In respect of
**Milton Place Car Park, Gravesham,
KENT**

Technical Note

2302-048/TN/01 | May 2025

SCALE: 1:500	DATE: 30/01/25	DRAWN: SMK	CHECKED: TS	APPROVED: SMK
JOB NO: 2302-048	DRAWING NO: SP09	REVISION: B

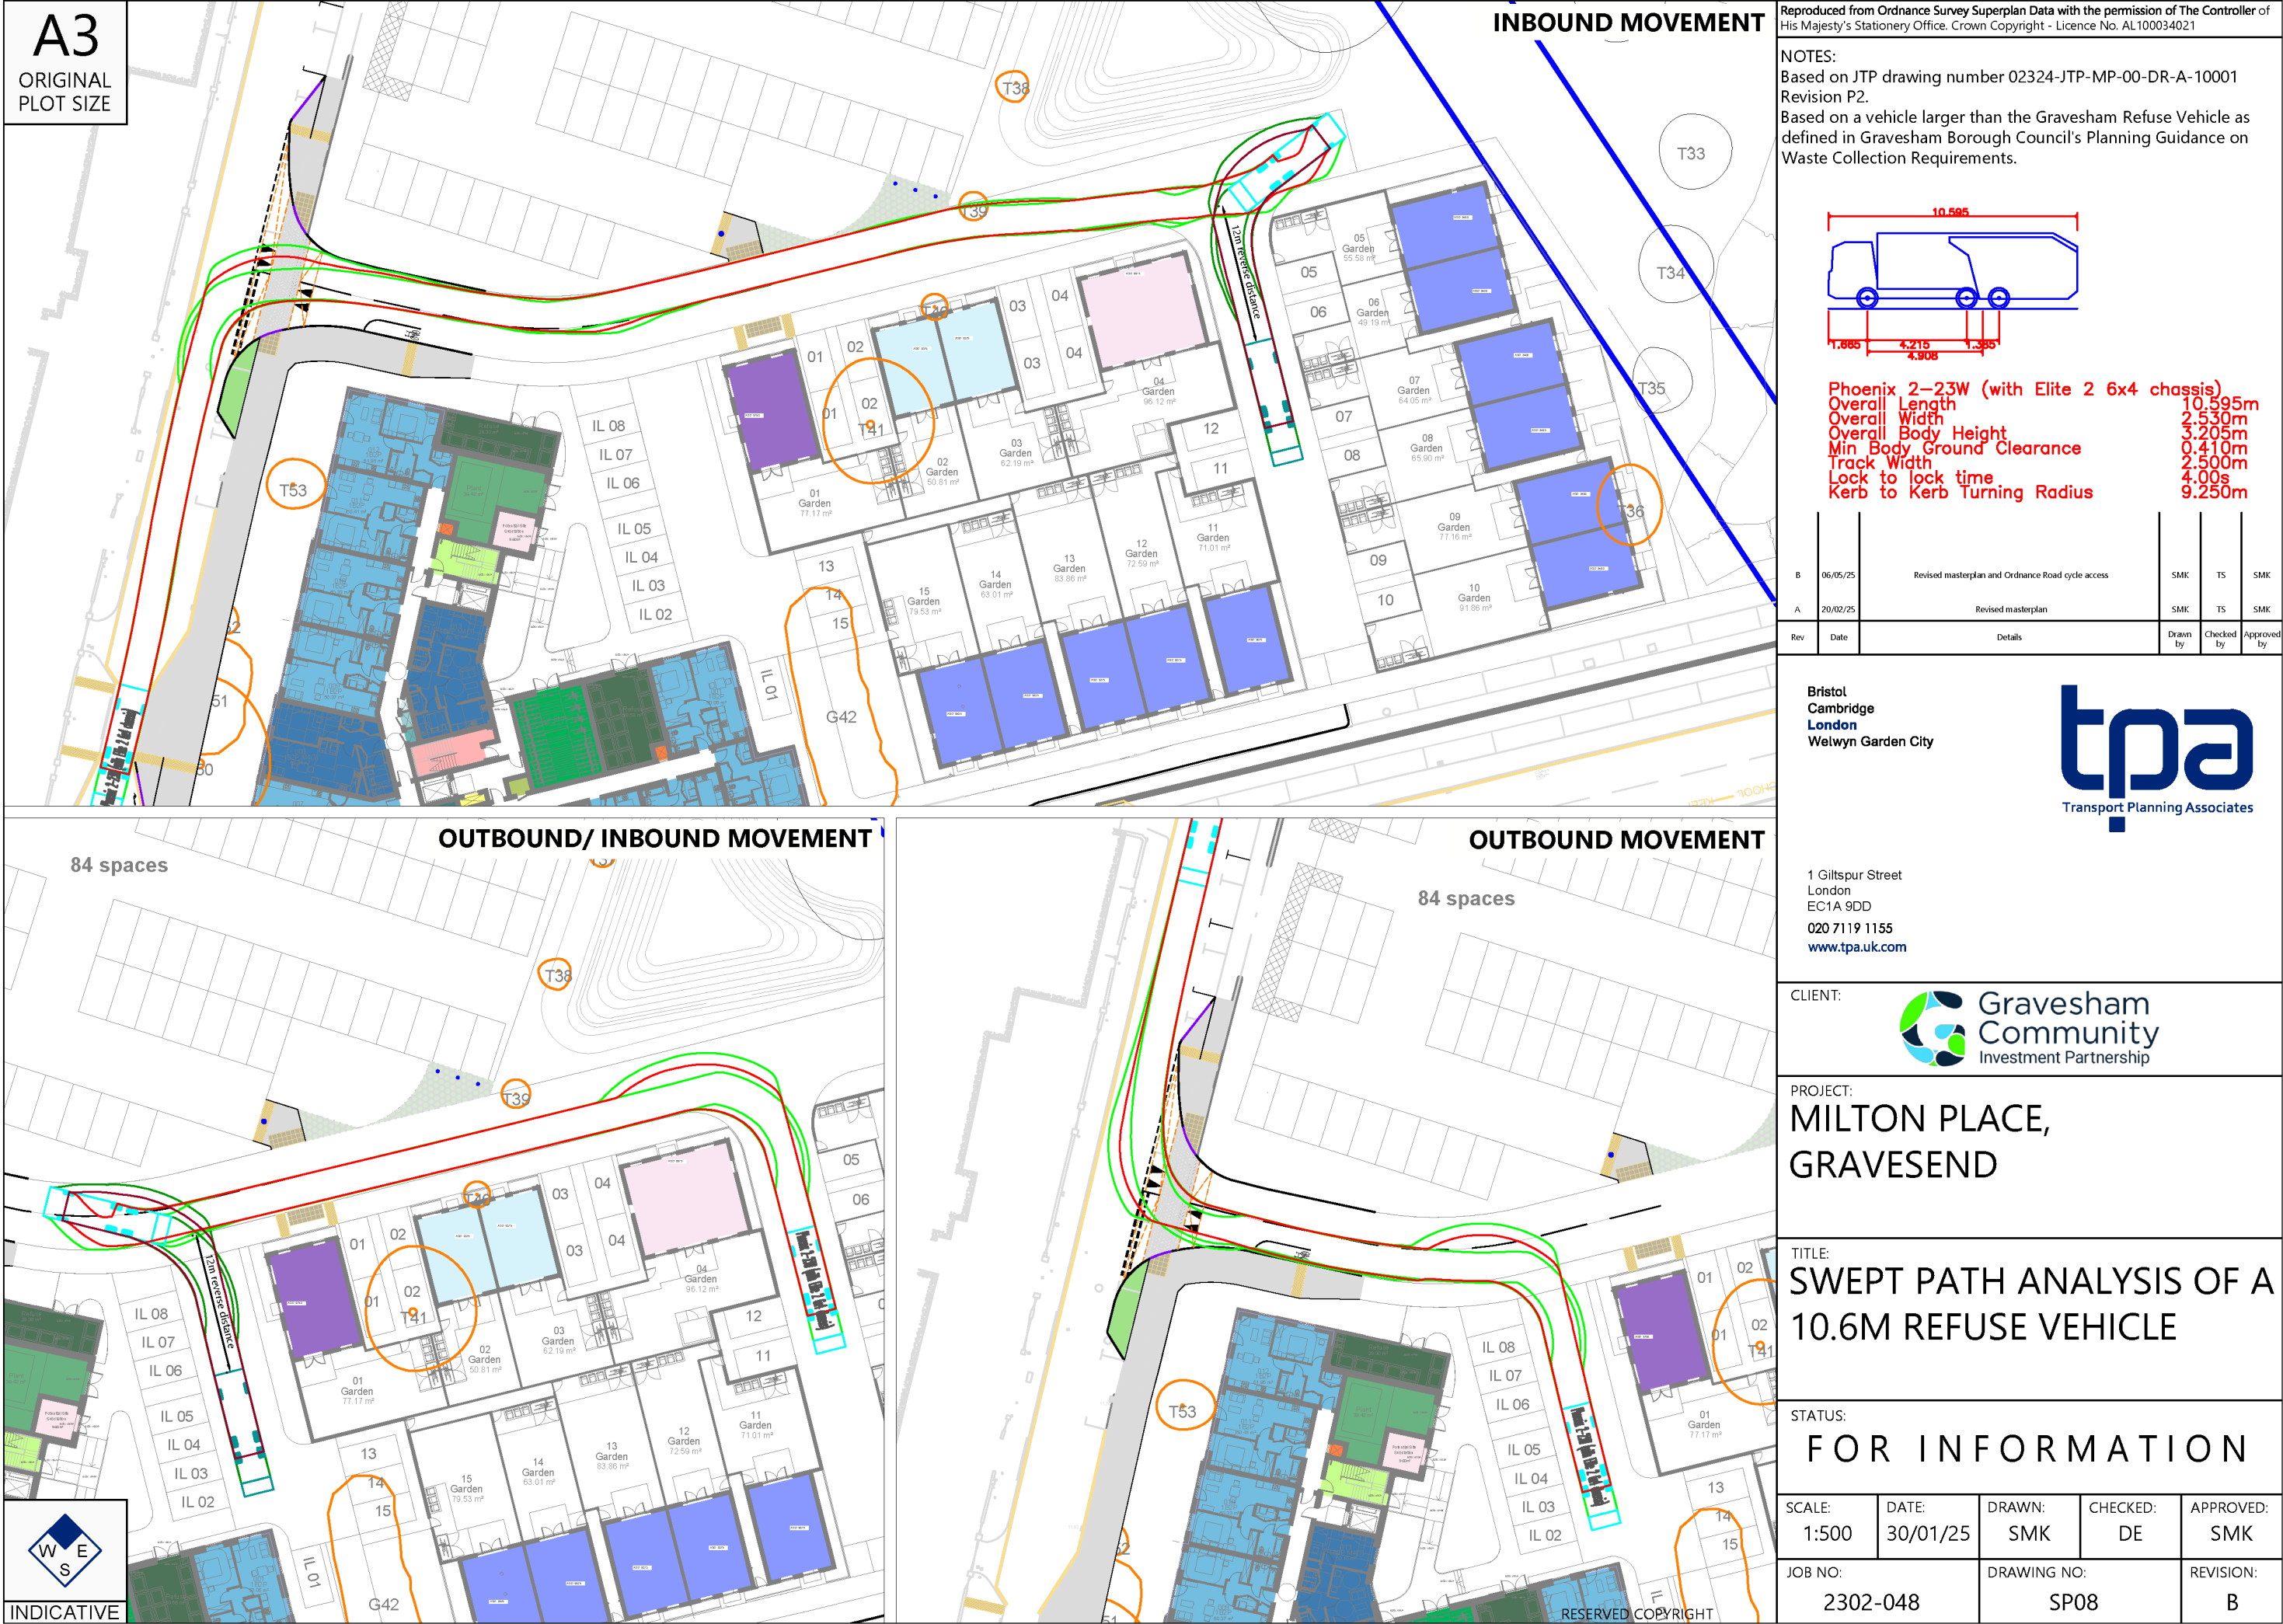
"Plan 2302-048 Rev A 'Proposed Site Access Arrangement', shows the running lane of the Ordnance Road car park to be partially covered by landscaping. It is assumed this is an error as the tracking shows vehicles over running this area. However, this should be confirmed. Please also confirm whether the width of the existing Ordnance Road car park aisle is to remain as existing, as the tracking for a car looks to be quite tight so larger vehicles would have difficulty accessing the bays."

Plan 2302-048 Rev A 'Proposed Site Access Arrangement', shows the running lane of the Ordnance Road car park to be partially covered by landscaping. It is assumed this is an error as the tracking shows vehicles over running this area. However, this should be confirmed. Please also confirm whether the width of the existing Ordnance Road car park aisle is to remain as existing, as the tracking for a car looks to be quite tight so larger vehicles would have difficulty accessing the bays.

- 2.18 It is acknowledged that the landscape arrangement is incorrect with landscaping shown in the aisle of the car park. This has been updated and is provided together with updated swept path analysis in **Appendix D**.

B	06/05/25	Revised masterplan and Ordnance Road cycle access	SMK	TS	SMK
A	20/02/25	Revised masterplan	SMK	TS	SMK
Rev	Date	Details	Drawn by	Checked by	Approved by

SCALE: 1:500	DATE: 20/02/25	DRAWN: SMK	CHECKED: TS	APPROVED: SMK
JOB NO: 2302-048		DRAWING NO: SP12		REVISION: A

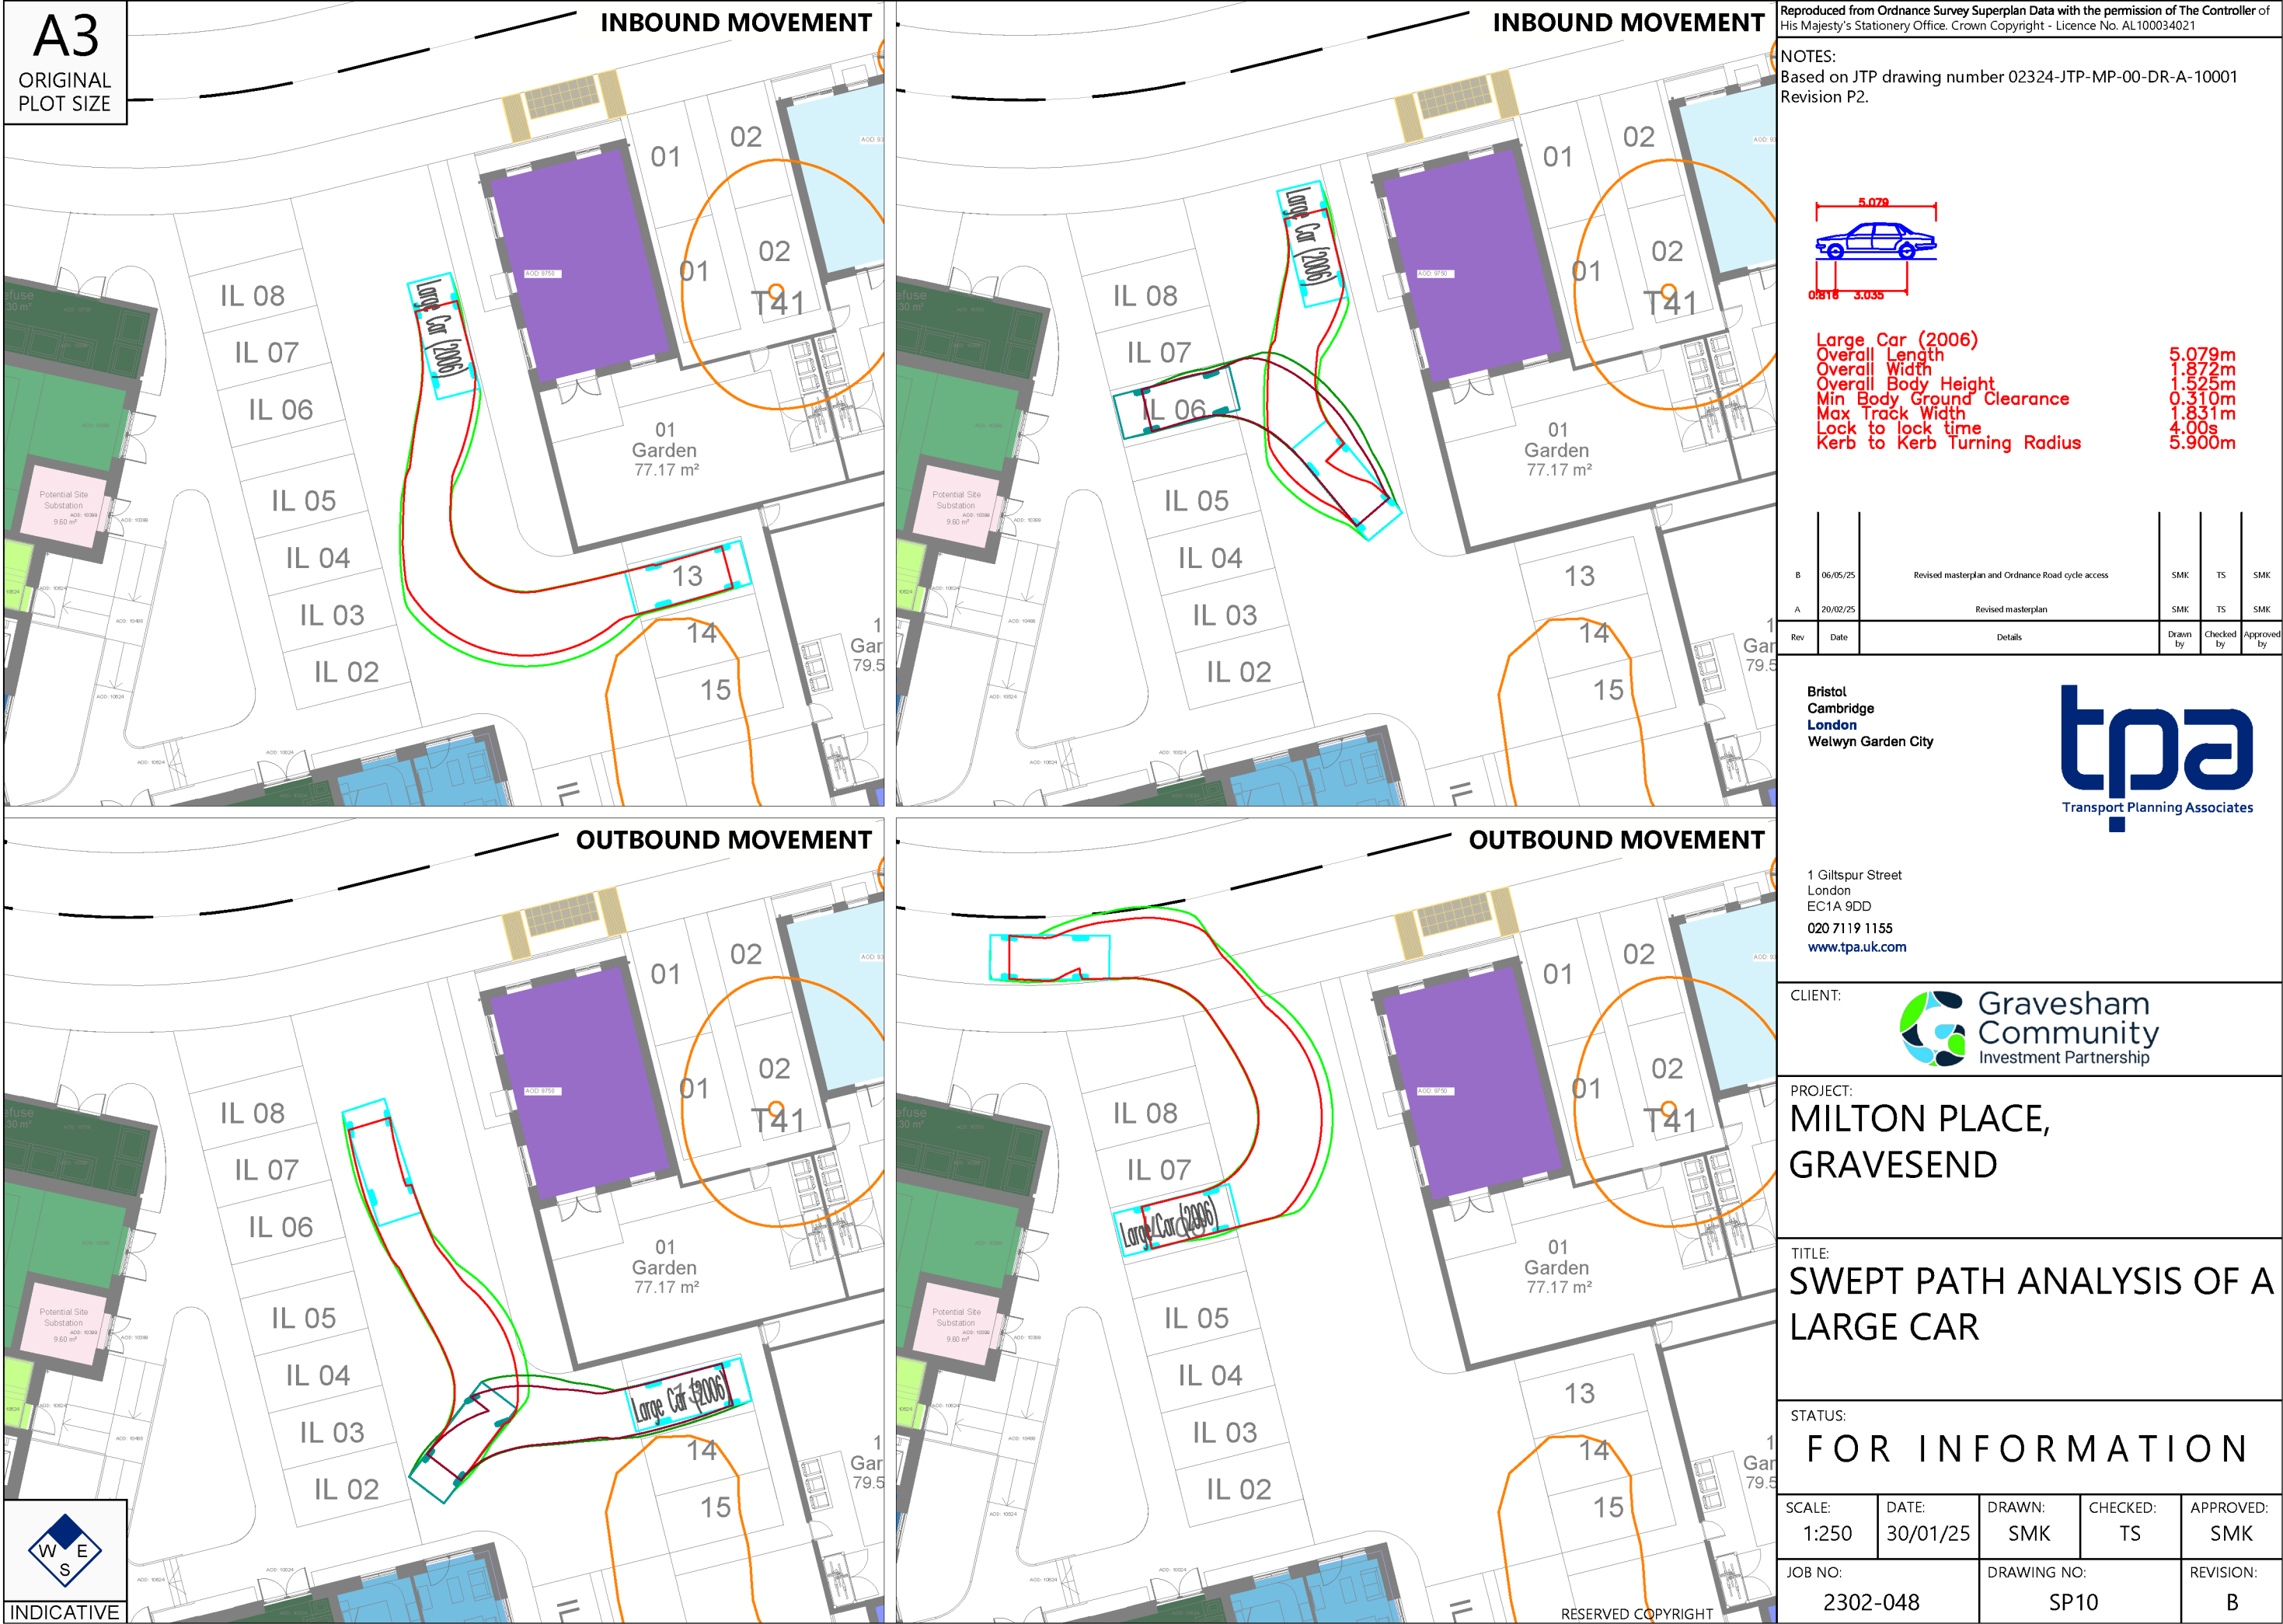
"A 10.6m refuse vehicle has been tracked to demonstrate that a refuse vehicle can access and egress the site in a forward gear. KCC usually require tracking for an 11.3m refuse vehicle as that is the largest vehicle that operates in Kent. As the access has been tracked for a 16.5m vehicle, the larger refuse vehicle will also be able to access the site from the highway. However, the larger refuse vehicle may have difficulty undertaking a three point turn within the site."

A 10.6m refuse vehicle has been tracked to demonstrate that a refuse vehicle can access and egress the site in a forward gear. KCC usually require tracking for an 11.3m refuse vehicle as that is the largest vehicle that operates in Kent. As the access has been tracked for a 16.5m vehicle, the larger refuse vehicle will also be able to access the site from the highway. However, the larger refuse vehicle may have difficulty undertaking a three point turn within the site.

- 3.2 Swept path analysis has been undertaken for a 10.6m refuse vehicle as a proxy for the refuse vehicle set out in Gravesham Borough Council's Planning Guidance on Waste Collection Requirements (August 2024) which states that *"The Council uses three-axle, rear steer 26 tonne collection vehicles:*
